Access Compliance Report

Public Rights-of-Way

Intersection ID: 2776	Main Street: BEAUVISTA_DR	Cross Street: OAK_COVE_LN	Location: SW
ADA ID: 0E8569ED1DBB	Ramp Type: PerpDiag	Initial Pass/Fail: Fail	Overall Compliance: No
		Severity Score: 10

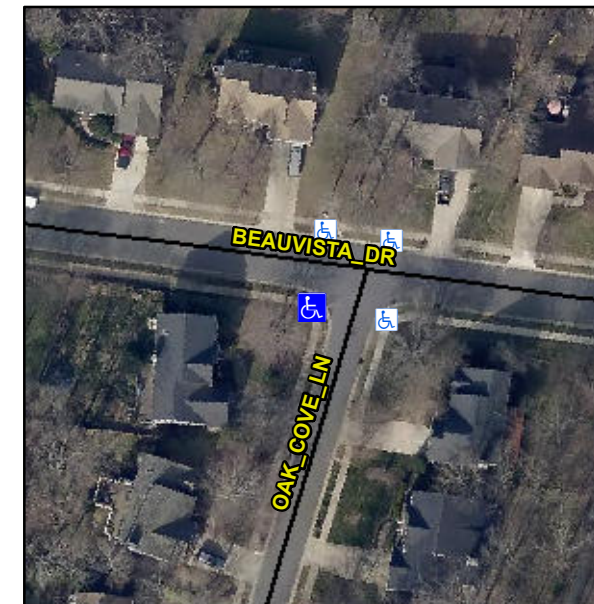
Not Found, R304.5.1, R304.5.3

Compliance	Description	Data	Compliance	Description	Data
N/A	Ramp Length (in)	46.5	Yes	Ramp Slope (%)	6.8
No	Ramp Width (in)	40.0	No	Ramp XSlope (%)	3.4
N/A	Flare Type LT	N/A	N/A	Flare Type RT	N/A
N/A	Flare Slope LT (%)	N/A	N/A	Flare Slope RT (%)	N/A
N/A	Flare Traversable LT?	N/A	N/A	Flare Traversable RT?	N/A
N/A	Landing Length (in)	N/A	N/A	DWS Provided?	N/A
N/A	Landing Width (in)	N/A	N/A	DWS Contrast?	N/A
N/A	Landing Slope (%)	N/A	N/A	DWS Length (in)	N/A
N/A	Landing X Slope (%)	N/A	N/A	DWS Full Width?	N/A
N/A	Landing Curb? (Y/N)	N/A	N/A	DWS Offset (in)	N/A
N/A	Shared Landing?	N/A			
N/A	Gutter Ponding?	N/A	N/A	Gutter Slope (%)	N/A
N/A	Gutter Lip Ht (in)	N/A	N/A	Gutter X Slope (%)	N/A
N/A	Painted X Walk1?	No	N/A	Painted X Walk2?	No
	X Walk 1 Direction	To E		X Walk 2 Direction	To N
N/A	X Walk 1 Width (in)	N/A	N/A	X Walk 2 Width (in)	N/A
	X Walk 1 Slope (%)	1.4		X Walk 2 Slope (%)	1.1
	X Walk 1 X Slope (%)	2.9		X Walk 2 X Slope (%)	0.6

Remove & Replace Curb Ramp With Two New Directional Ramps or Equivalent.
